**RE: MOOLARBEN COAL COMPLEX SITE VERIFICATION CERTIFICATE APPLICATION  
(14\_6609)**

**ENCLOSURE 1**  
**RECONCILIATION OF OEH COMMENTS**

**ENCLOSURE 2**  
**REVISED SOIL MAP AND SUPPORTING METADATA**

Soil Landscape Units

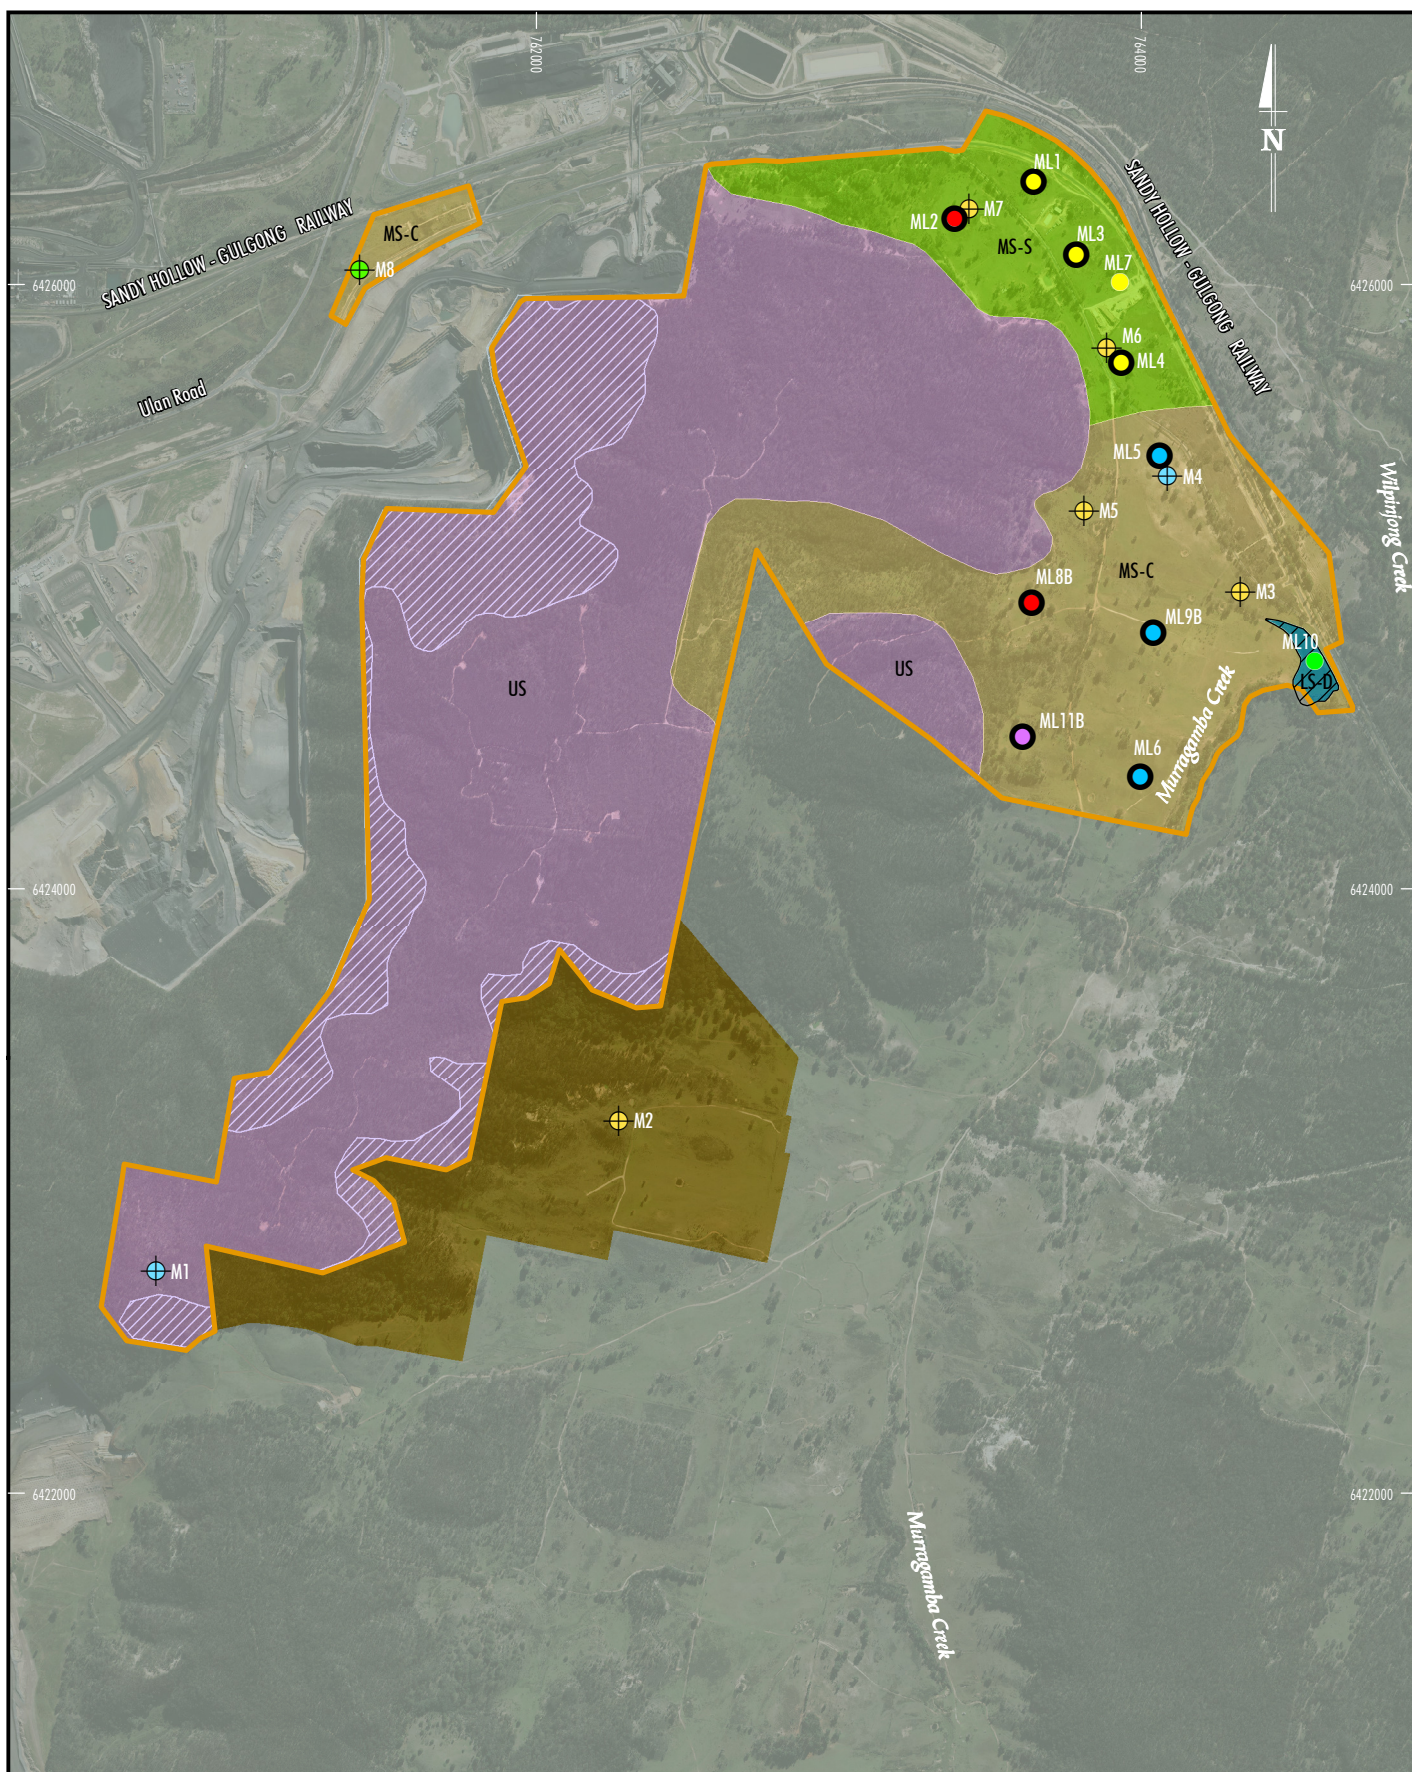
MAPS				
2	Geographically accurate base map (at 1:25,000) of assessment area supplied as per <i>Interim Protocol</i> . Spatial dataset (boundary of assessment area) supplied in GIS format as per <i>Interim Protocol</i> .	X			No response required.
3	Soil map (at 1:25,000) of project area supplied including all observation (Detailed, Check and Exclusion) sites as per <i>Interim Protocol</i> . Spatial datasets (soil map, observation sites and data reliability/data source diagram) supplied in GIS format as per <i>Interim Protocol</i> .		X	<p>Soil types can be inferred from the "soil landscape map" (<b>Figure 9</b>) and <b>Table 3</b> in the report. The revised soil type map (<b>figure 9</b>) was not supplied in GIS format.</p>	<p>The relevant spatial information from Figure 9 was provided in GIS format (i.e. shapefiles) as Attachment 3 of the letter to the Department of Planning and Environment dated <b>3 December 2014</b> under the shapefile names "MMC_Soil_LandscapeUnits" and "ASC_Sampling_Oct2014".</p> <p>This was discussed further with OEH who subsequently stated the following with regard to the GIS files (email dated 13 January 2015):</p> <p><i>All this information appears to be adequate.</i></p> <p>Notwithstanding, a revised soil map was prepared as a result of the additional desktop and field investigations and is presented in Enclosure 2. The GIS files for the Soil Map have been provided to OEH, who subsequently confirmed they are satisfactory (email dated 9 March 2015). The GIS files are also included with this letter.</p>

6	Metadata for spatial datasets have been provided as per the <i>Interim Protocol</i> .		X	The metadata provided for the spatial data is not compliant with the ISO 19115 standard, as required by the <i>Interim Protocol</i> .	This was discussed further with OEH who subsequently stated the following with regard to the original metadata supplied (email dated 13 January 2015):  <i>All this information appears to be adequate.</i>  Consistent with the previous metadata, the metadata for the new Soil Map complies with the requirements of ISO19115 (i.e. no 'exclamation marks' shown against any of the metadata elements). This metadata has been provided to OEH who have confirmed it is satisfactory (email dated 9 March 2015).
<b>LODGEMENT OF SITE LABORATORY DATA</b>					
7	All Site observations lodged on BSAL Soil Data Cards and all required field attributes completed correctly for each observation type as per the <i>Interim Protocol</i> (i.e. <b>check, exclusion and detailed</b> ).	X		None of the 8 sites described in the original application are valid for BSAL site assessment under the <i>Interim Protocol</i> , as none qualify as either Detailed, Check or Exclusion sites, and could not be loaded into SALIS. Several requests to the proponent have not so far resulted in receipt of any corrections or additional data that would bring these sites up to the standard required for BSAL assessment. These sites have therefore not been included in OEH's assessment of the SVC application.  The additional 11 sites provided in the supplementary report (whose numbers overlap the original 8 sites) were provided on BSAL Soil Data Cards and are adequately described for use in BSAL assessment.	Noted. This issue was discussed further with OEH who subsequently stated the following with regard to the supplementary field work undertaken in October 2014 and January 2015 (email dated 6 March 2015):  <i>The original check sites have not been considered in our assessment. However, you are correct in that the supplementary field work undertaken in October 2014 and January 2015 has been sufficient for the application. OEH considers the assessment is adequate based on the information supplied during this supplementary field work.</i>

A revised Soil Map incorporating the outcomes of the supplementary desktop and field investigations is provided in Enclosure 2, along with supporting GIS files and metadata.
